U.S. Department
of Transportation
**Federal Highway
Administration**

In Reply Refer To:
HSST/B-218

Name of system: F-Shape Reinforced Concrete Barrier with Slotted Drain Holes
Type of system: Permanent F-Shape Reinforced Concrete Barrier
Test Level: National Cooperative Highway Research Program (NCHRP) Report 350
Test Level 4 (TL-4)
Testing conducted by: Texas Transportation Institute (TTI)
Date of Request: December 9, 2010
Drawing Designator: SBC04d

Figure 76 – LaDOTD F-Shape Barrier, TXDOT Wildlife Crossing Barrier WSDOT Pin & Loop Barrier Cross-Sections

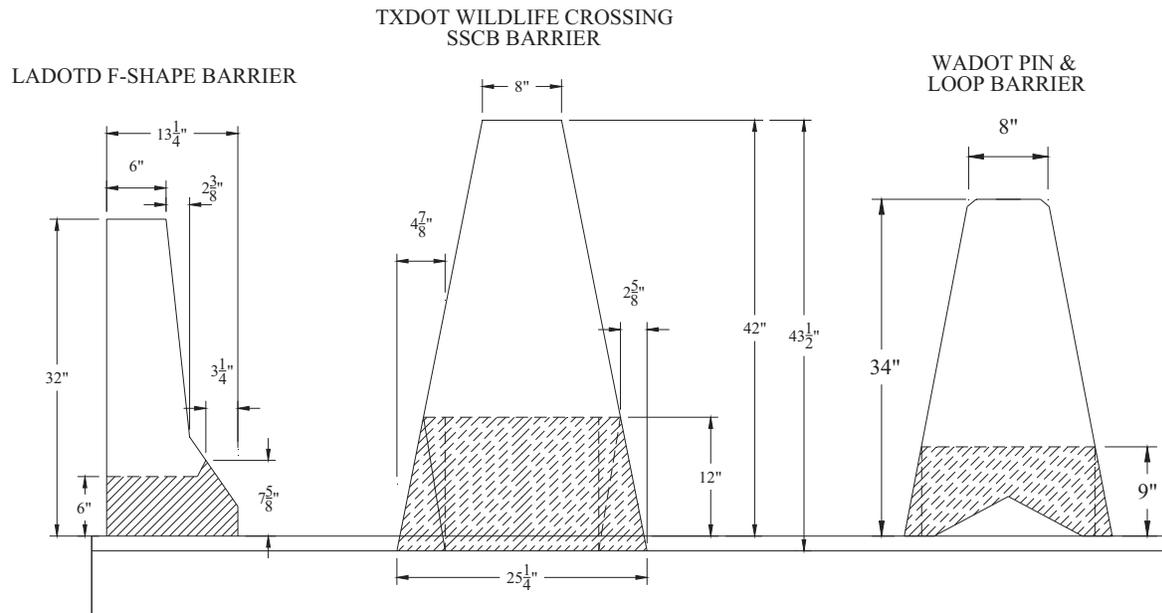
The proposed drainage slot details were compared with other barriers systems utilizing similar type slots. This review consisted of comparisons with the Texas Department of Transportation (TXDOT) Single Slope Concrete Barrier (Wildlife Crossing) Precast SSCB (TXDOT Wildlife Crossing Barrier) and the Washington Pin & Loop Barrier System designed and successfully crash tested by TTI for the Washington State Department of Transportation (acceptance letter HSSD/B-206). The TTI researchers performed a similar review of the TXDOT Wildlife Crossing Barrier for TXDOT with respect to the size and potential interaction of these openings with respect to the small car and pickup truck for the NCHRP Report 350 crashworthiness criteria.

The ratio in height of the contact length of the F-Shape Barrier to 32 inches total height of rail (i.e., rail contact width to height) is 0.762. Based on the proposed barrier geometry and the information provided in AASHTO Figure A13.1.1-3, the proposed barrier is considered marginal.

The analysis of the drainage slot used in the Washington State Department of Transportation Pin & Loop Barrier (WSDOT barrier) appeared to perform well in LS-DYNA impact simulations with both the small car and pickup truck. Although the WSDOT barrier did not meet the AASHTO Manual for Assessing Safety Hardware test specifications, the 9-inch high drainage slot specified used in the WSDOT barrier system did not adversely affect the performance of the crash vehicle. In addition, the potential for vehicle interaction with the drainage slot opening was considered low to marginal with respect to the criteria as provided in AASHTO Section 13 specifications. Based upon the researchers' analysis, the F-Shape barrier with drainage slots is considered acceptable with respect to Report 350 TL-4 performance criteria.

Therefore, the system as described in the request above and detailed in the enclosed drawings is acceptable for use on the NHS under the range of conditions tested, when such use is acceptable to a highway agency.
